**Westside Middle School Addition & Renovation –  
Final Bid  
ADDENDUM NO. 1**

## ADDENDUM

**ADDENDUM NO.:** #01

**PROJECT:** Westside Middle School Cafeteria Addition

# C1.5

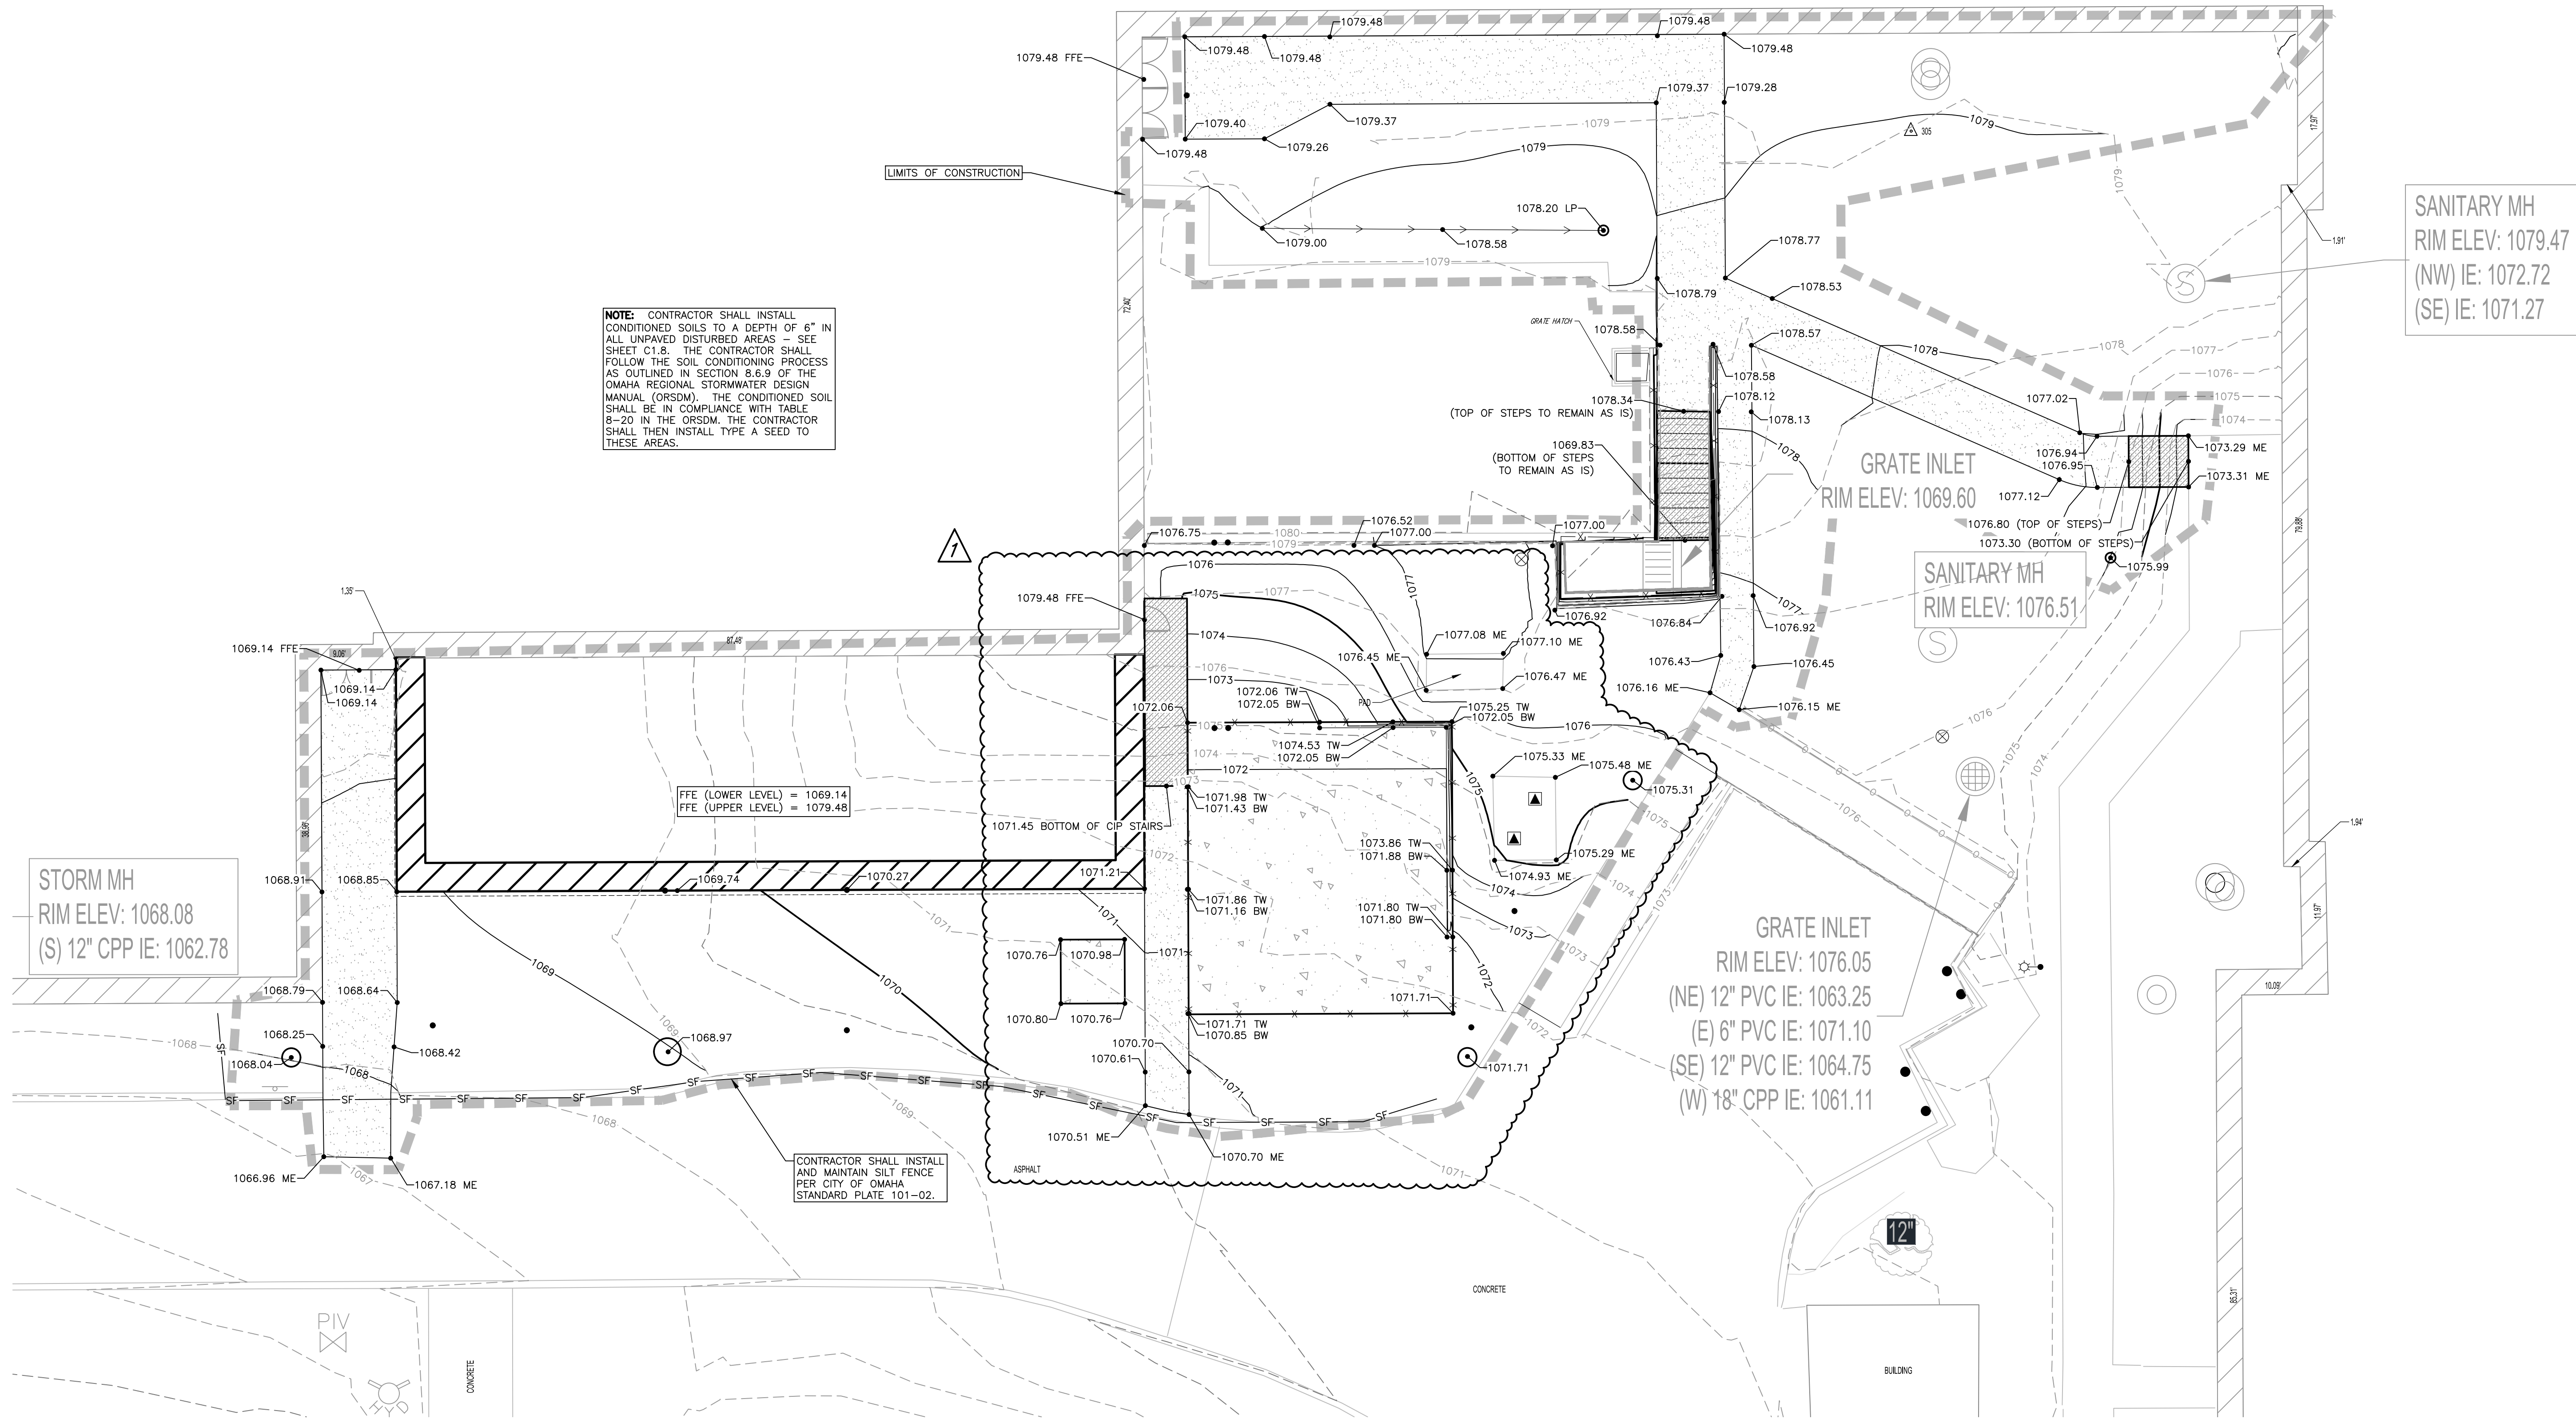
1. C1.3 - Zoning Compliance Plan
  - a. Chiller pad and retaining wall moved
2. C1.5 - Grading Plan
  - a. Chiller pad and retaining wall moved, grading updated accordingly
3. C1.6 - Paving Plan
  - a. Chiller pad and retaining wall moved, paving updated accordingly
4. C1.7 - Utility Plan
  - a. Chiller pad and retaining wall moved

# S1.1

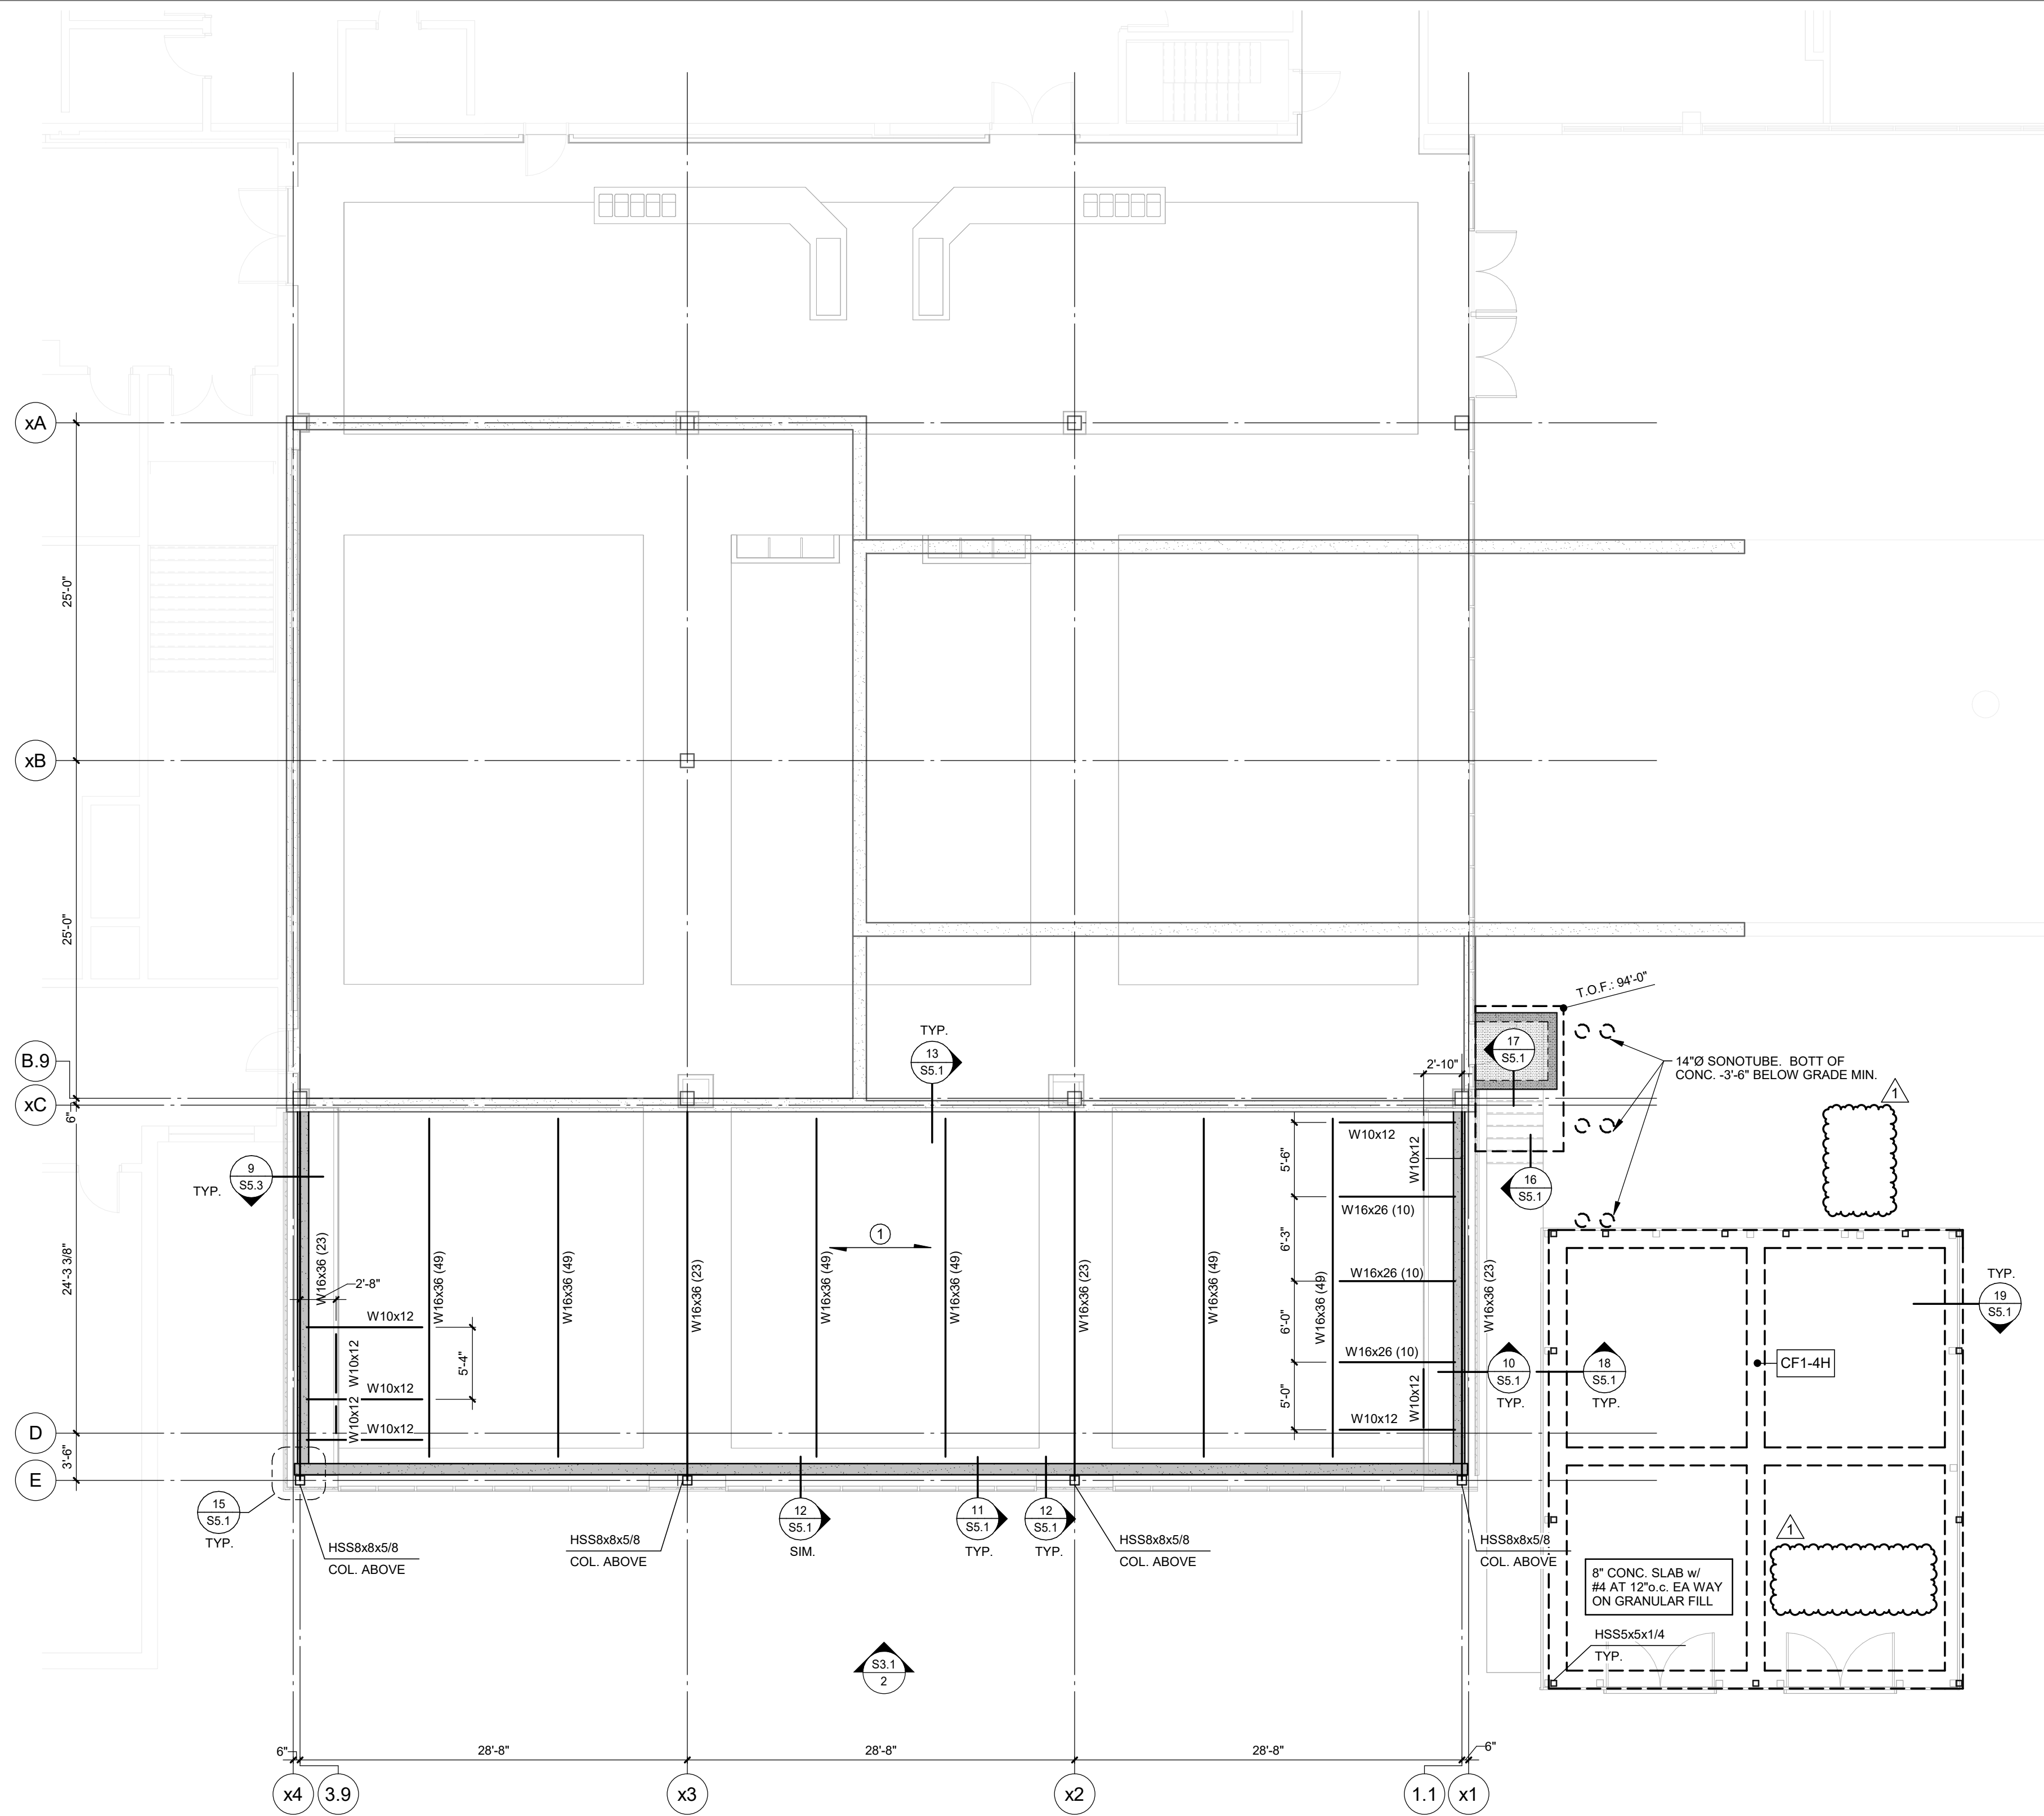
8. S1.1 - Foundation & First Floor Framing Plans
  - a. Chiller pad and retaining wall moved and revised
9. S5.1 - Structural Sections
  - a. 19/S5.1 - Section added for retaining wall

## MD0.0

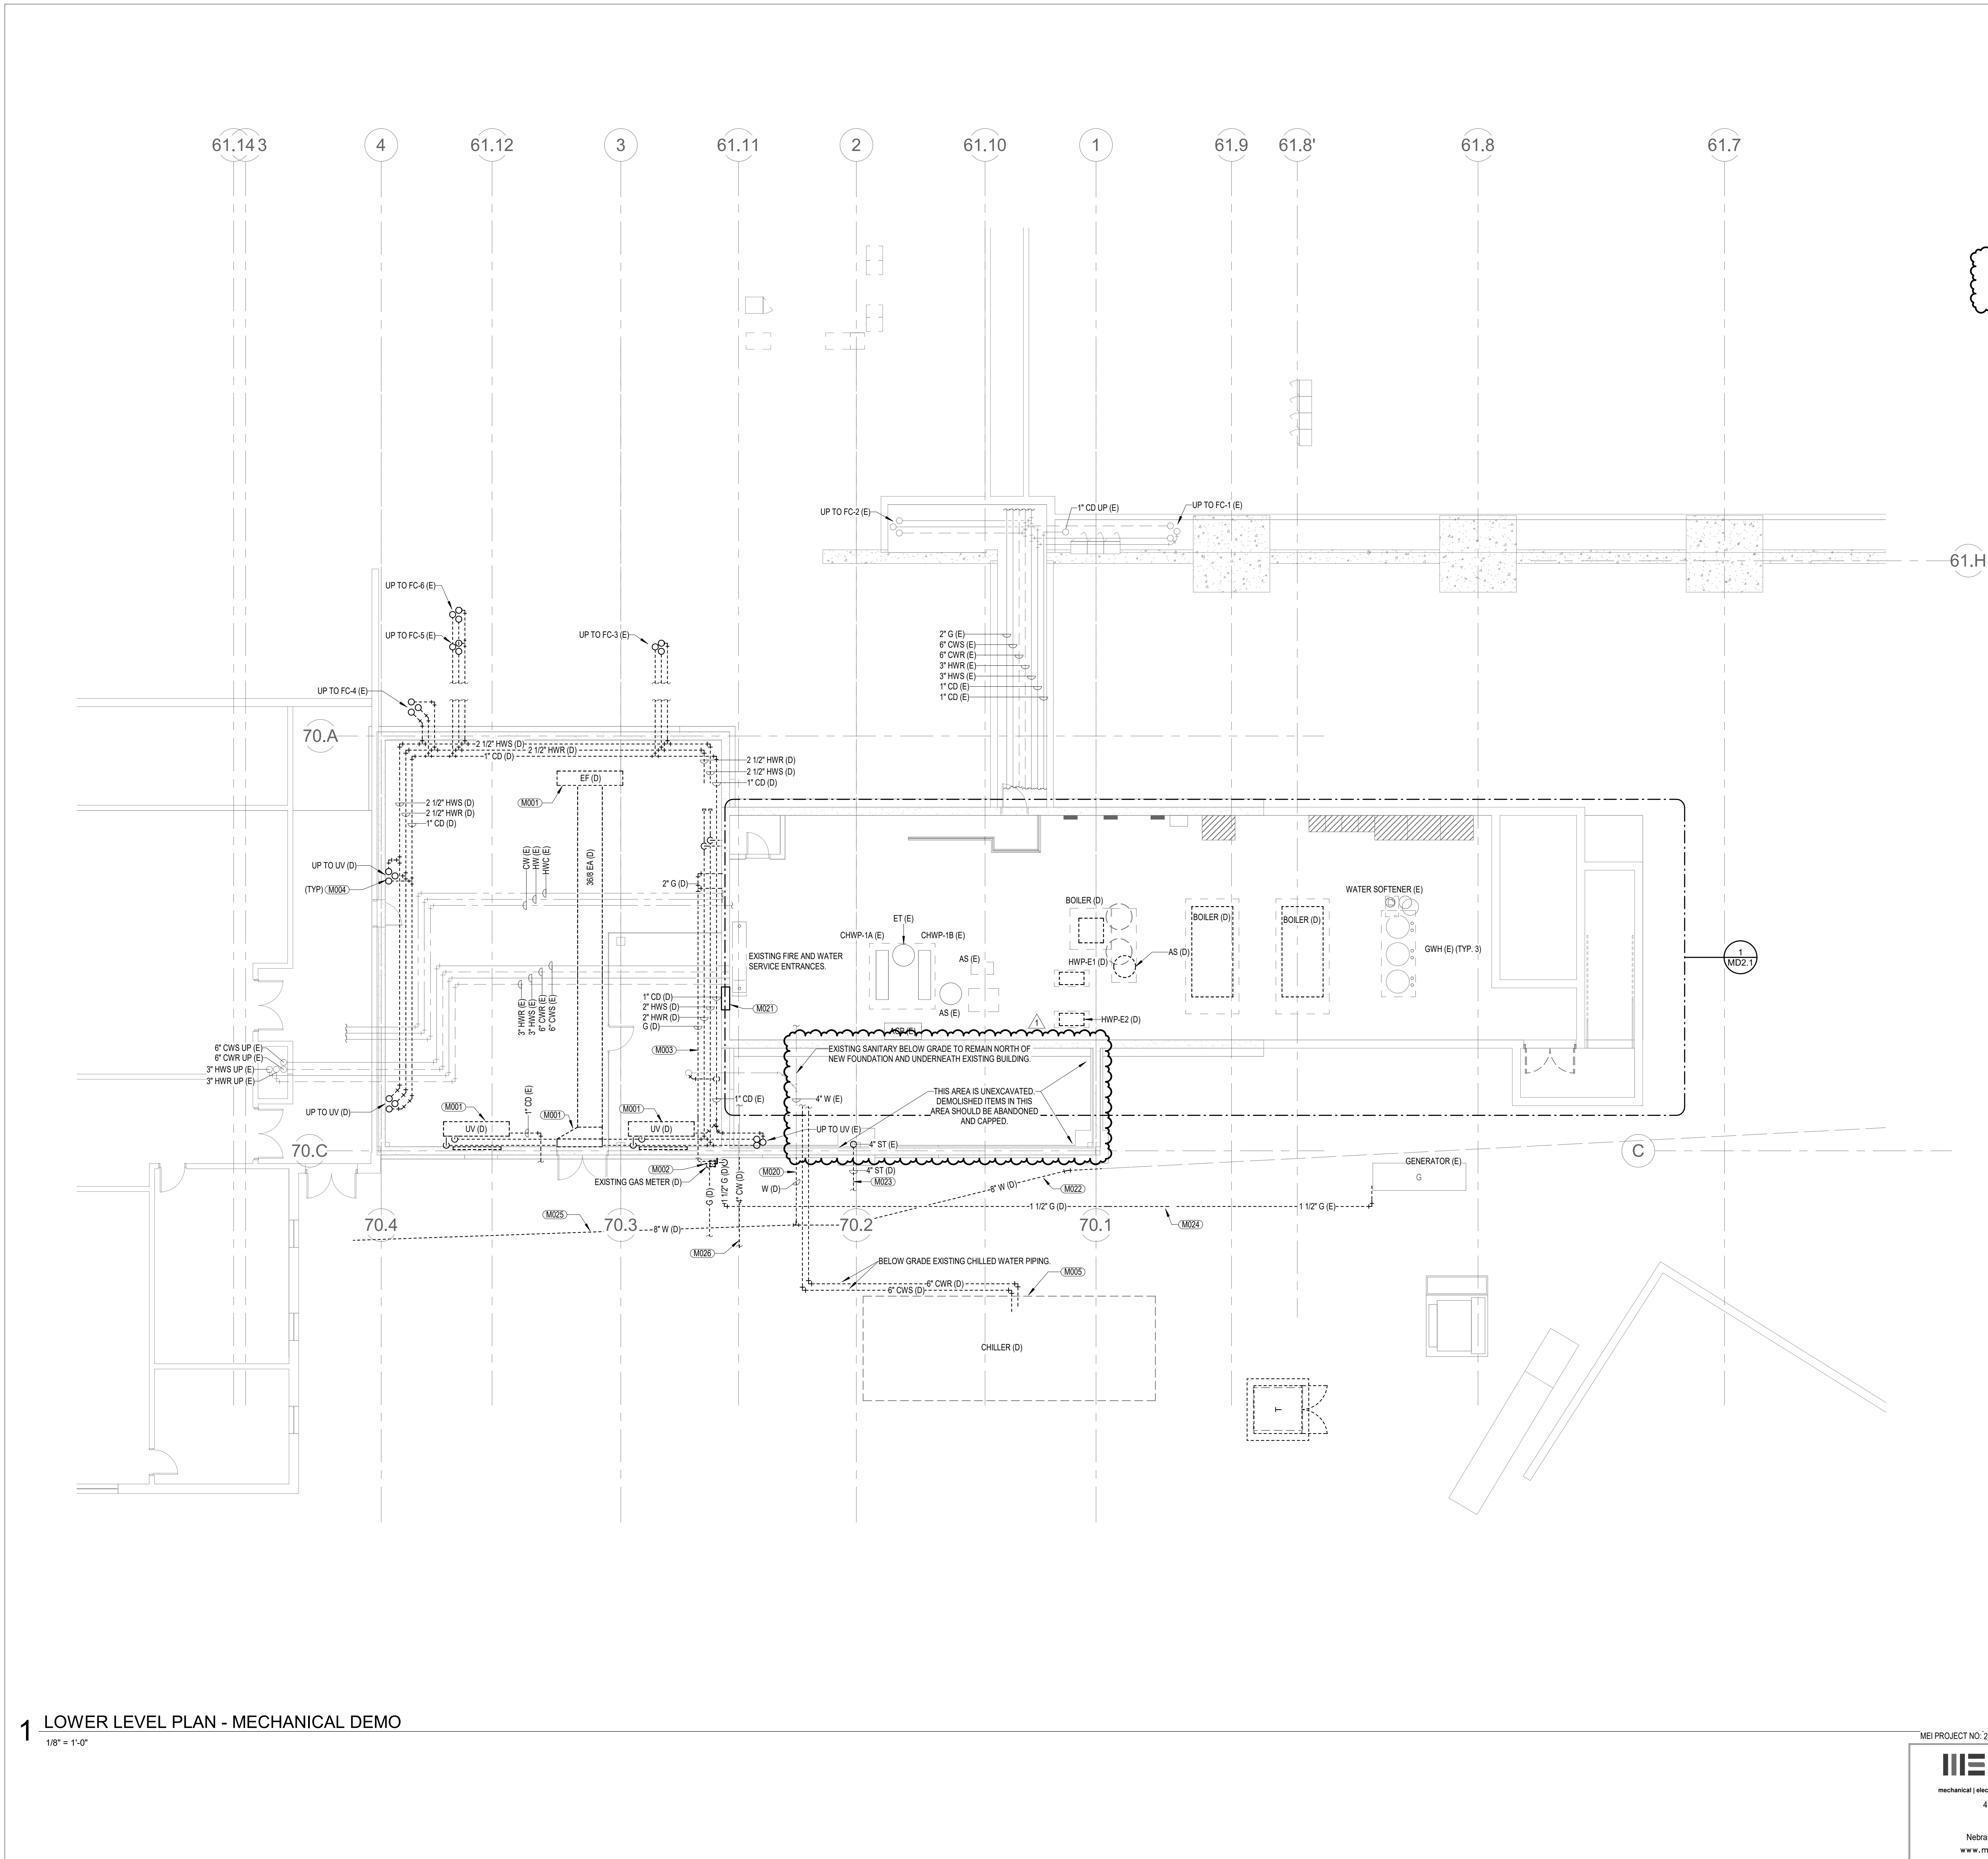
10. Sheet MD0.0 – LOWER LEVEL PLAN – MECHANICAL DEMO
  - a. Add note for unexcavated area on plan.
  - b. Adjust keynotes M021, M022.
11. Sheet MD1.0 – FIRST FLOOR PLAN – MECHANICAL DEMO
  - a. Adjust keynote M013.
12. Sheet M1.0 – LOWER LEVEL PLAN - HVAC
  - a. Add AHU-C plan/elev view to this sheet.
  - b. Adjust location of chillers on plan.
13. Sheet M2.0 – LOWER LEVEL PLAN – MECHANICAL PIPING
  - a. Adjust keynote M216.
  - b. Adjust chiller piping supports.
  - c. Add note for cold water connection to civil.
  - d. Adjust location of chillers on plan.
  - e. Add note for chiller orientation.
